Public Consultation - Dodder Greenway Route Scheme

I am writing on behalf of the Dublin Cycling Campaign to give our views on the proposed Dodder Greenway route from Bohernabreena to Rathfarnham. In general we broadly welcome the proposed upgrade of the facilities but we have reservations that a world-class Greenway will be achieved with the present proposed design. If the route is designed to a high standard it can provide a safe, quiet and scenic route for cyclists, walkers and joggers of all ages. And, since much of the route is close to residential areas, it will provide an alternative route to encourage commuters to switch from driving to cycling, and students to cycle to college. We urge the Council to review the proposed design thoroughly, before proceeding with the work.

Figure 3- Overgrown riverside path at Springfield Avenue

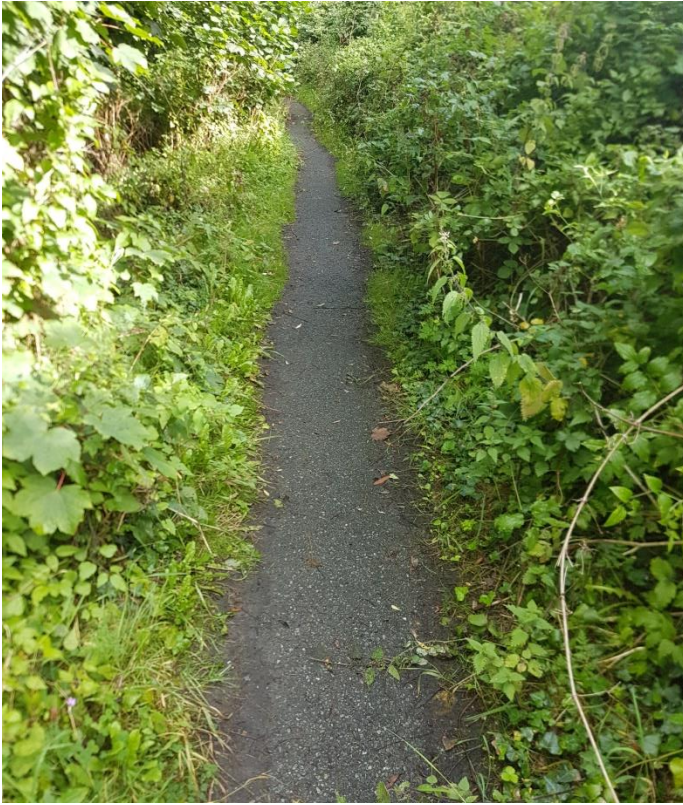
- a. There is no reason why pedestrian and cycling movement cannot be separated along this stretch of Springfield Avenue. This is easily done and there is a need to create a clear 2-way cycle only route on the north side of Springfield Avenue, which should be separated totally from pedestrians, and the pedestrian route accommodated closer to the river along the existing track. This may necessitate a small bridge across the River Owendoher for the pedestrian link, or alternatively a very short shared stretch along the existing north side footpath area.
- b. The existing tracks near the river are not shown. These are overgrown and not well maintained, but they should be maintained to provide an alternative route for pedestrians and joggers that is quieter (less traffic noise) and one that does not have the risk of conflict with cyclists.
